## **ADDENDUM #1**

Emma Wilson ES – Summer 2019

**Chico Unified School District**

**Addendum No. 1 to Bidding Documents for the  
Emma Wilson ES – Summer 2019 Project  
Date: April 16, 2019**

1AS1.0  
75-18118-00  
Revisions

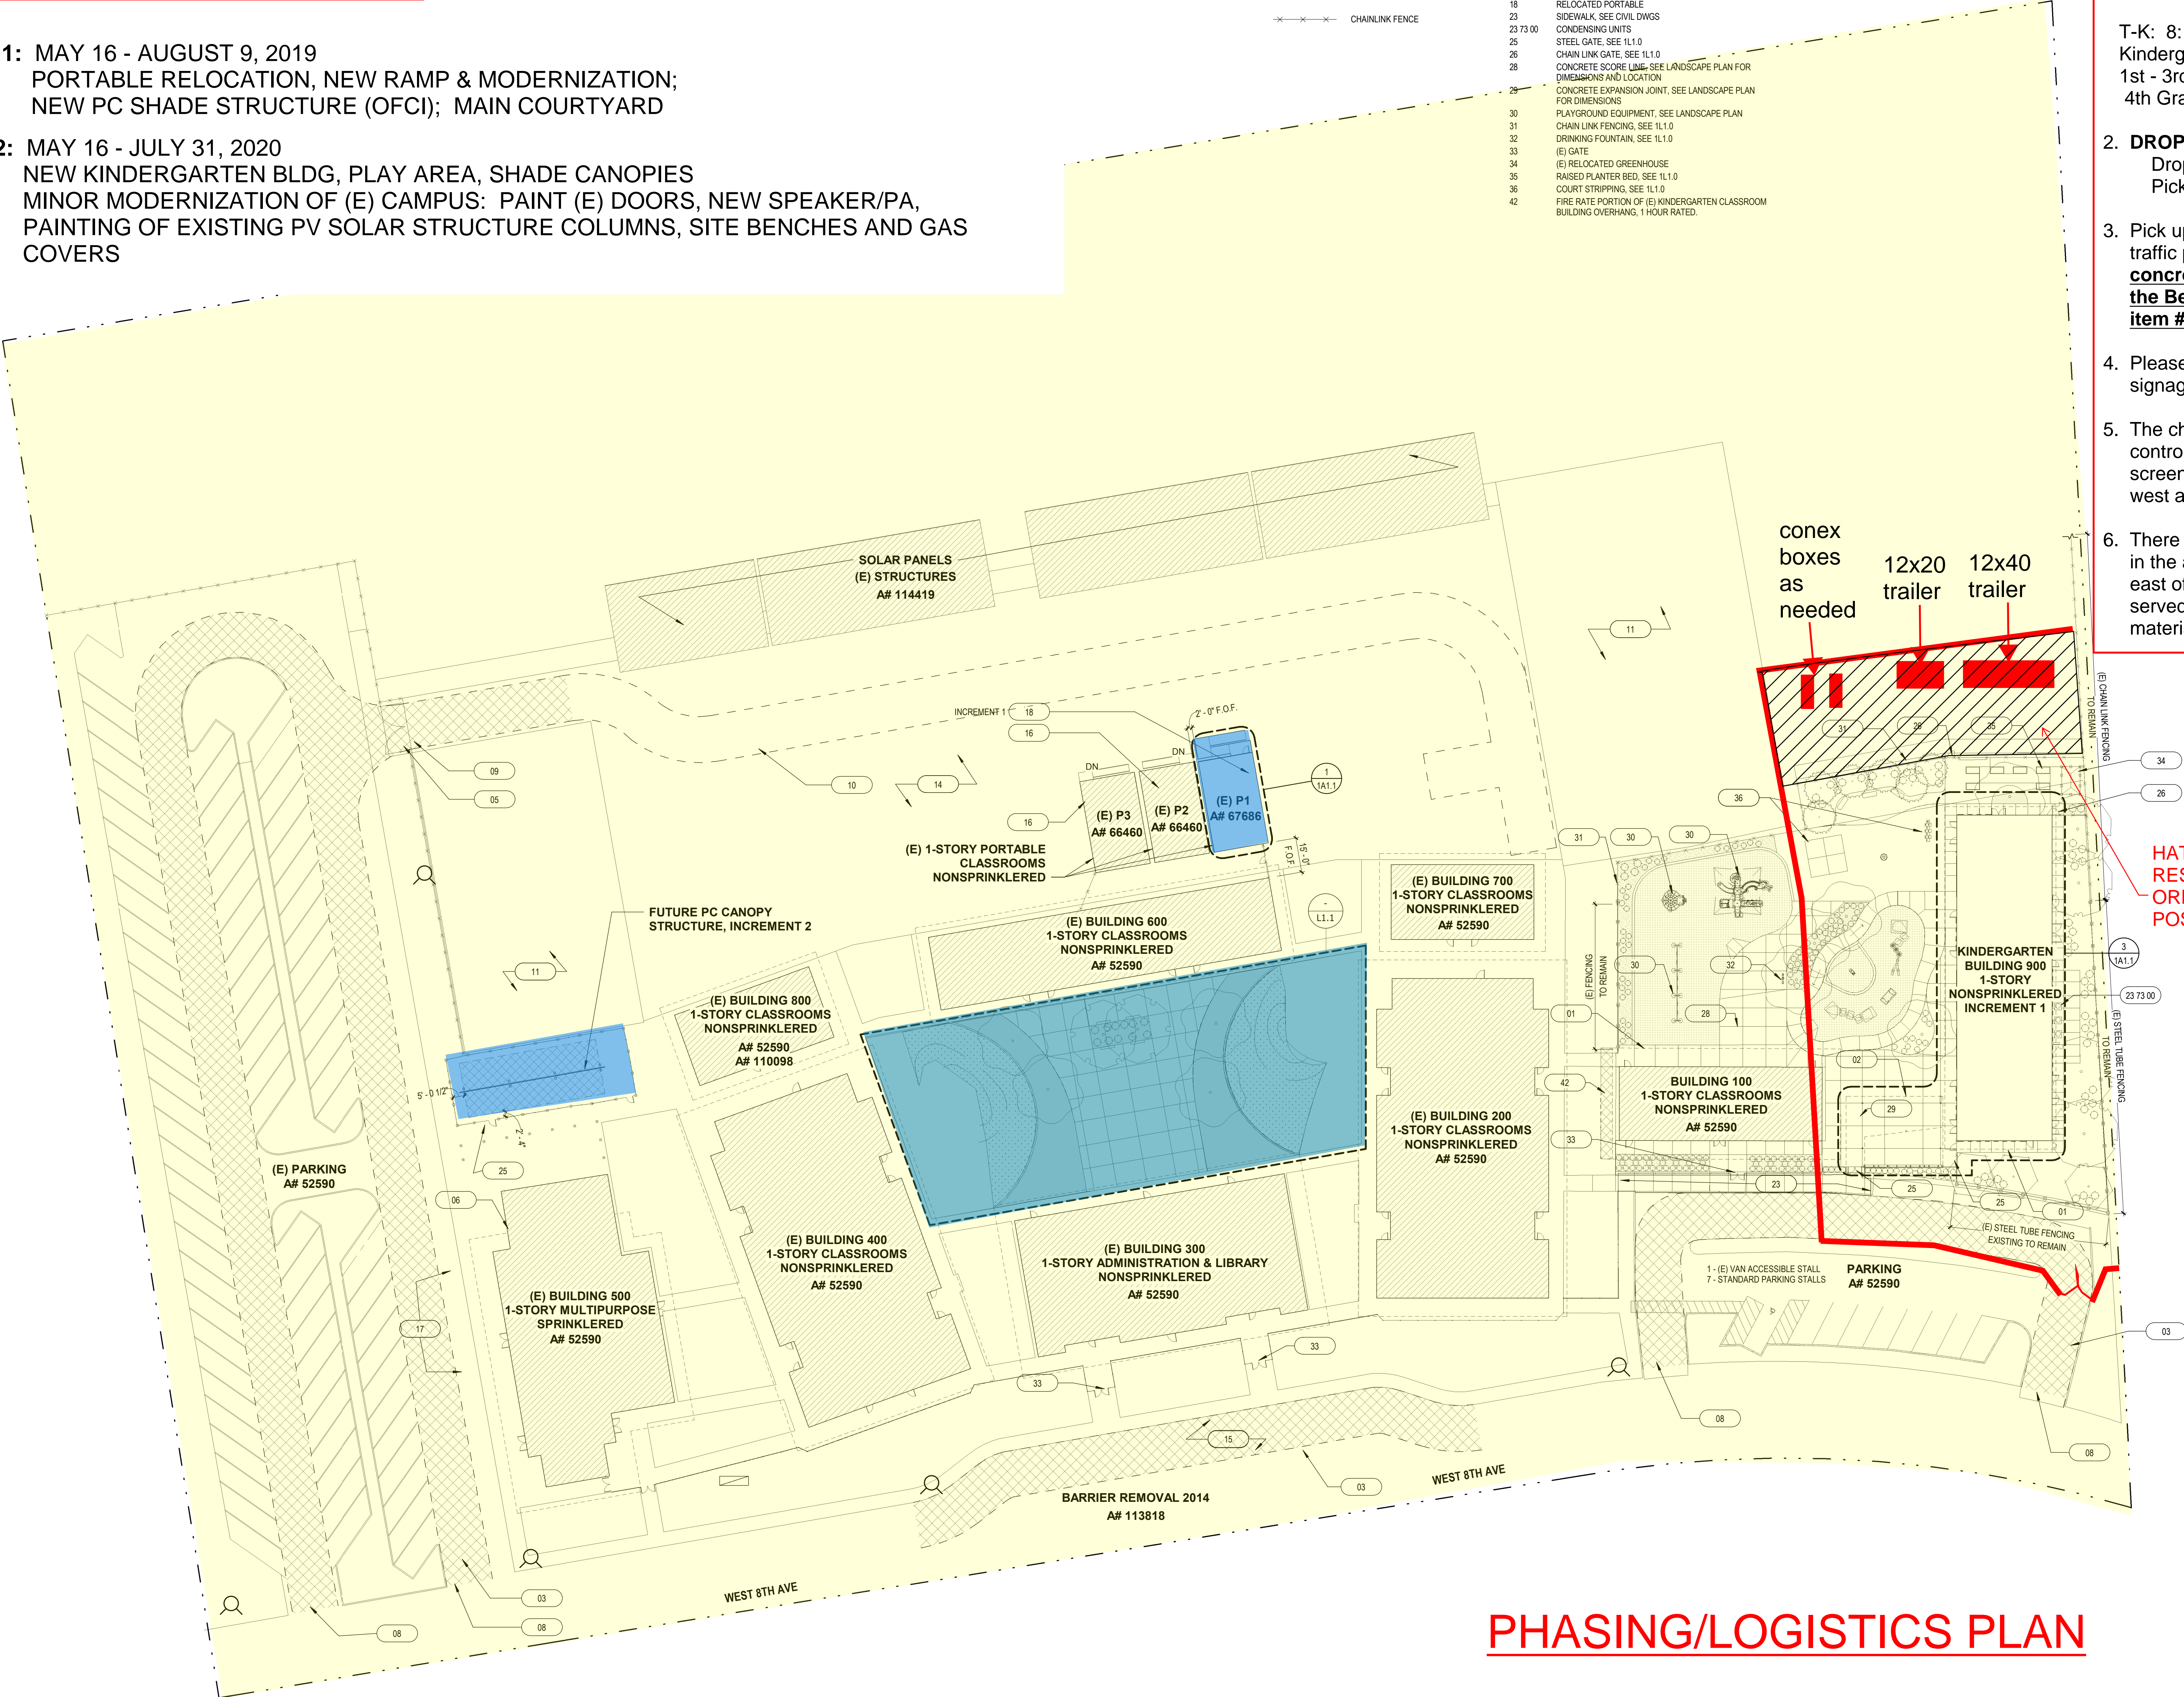
CONSTRUCTION DURATION: 418 DAYS TOTAL

MILESTONE 1: NTP: May 16, 2019 (Submittals & Preconstruction)

MILESTONE 2: June 10, 2019, Construction Start

MILESTONE 3: August 9, 2019 Completion Phase 1

MILESTONE 4: July 31, 2020 Final Completion, Phase 2

- PHASE 1:** MAY 16 - AUGUST 9, 2019  
PORTABLE RELOCATION, NEW RAMP & MODERNIZATION;  
NEW PC SHADE STRUCTURE (OFCI); MAIN COURTYARD
- PHASE 2:** MAY 16 - JULY 31, 2020  
NEW KINDERGARTEN BLDG, PLAY AREA, SHADE CANOPIES  
MINOR MODERNIZATION OF (E) CAMPUS: PAINT (E) DOORS, NEW SPEAKER/PA,  
PAINTING OF EXISTING PV SOLAR STRUCTURE COLUMNS, SITE BENCHES AND GAS  
COVERS
